Blue = discussed and ok

Addendum 109: Regulation No. 110

Revision 2

- I. SPECIFIC COMPONENTS OF MOTOR VEHICLES USING COMPRESSED NATURAL GAS (CNG) AND OR LIQUIFIED NATURAL GAS (LNG) IN THEIR PROPULSION SYSTEM;**
- II. VEHICLES WITH REGARD TO THE INSTALLATION OF SPECIFIC COMPONENTS OF AN APPROVED TYPE FOR THE USE OF COMPRESSED NATURAL GAS (CNG) AND OR LIQUIFIED NATURAL GAS (LNG) IN THEIR PROPULSION SYSTEM**

Provisions regarding LNG identification mark for public service vehicles (M2 and M3)

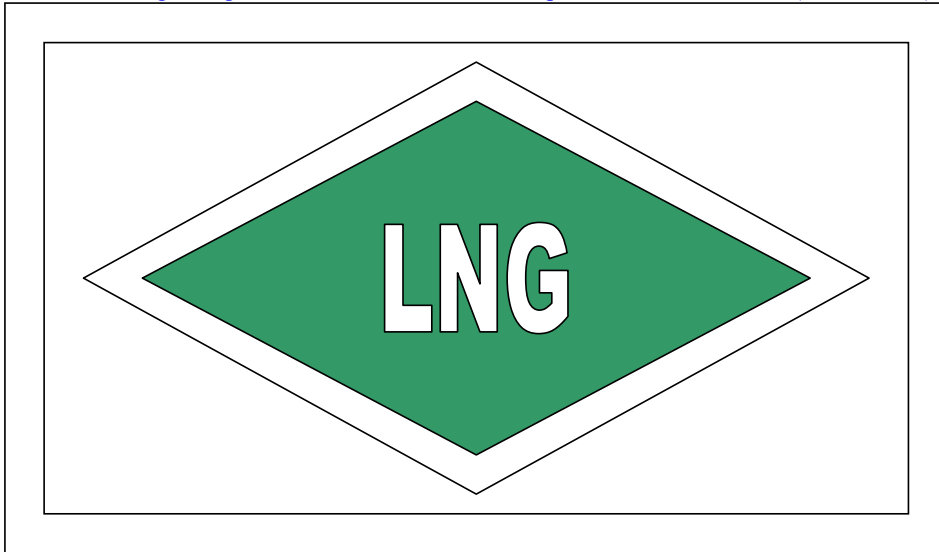
Comment [pc37]: The purpose of this label is to prevent the system for overfilling and not complying with the 5 day hold time.

A label should be placed adjacent to the fill receptacle stating the required fuel properties. The required fuel properties should be as recommended by the manufacturer.
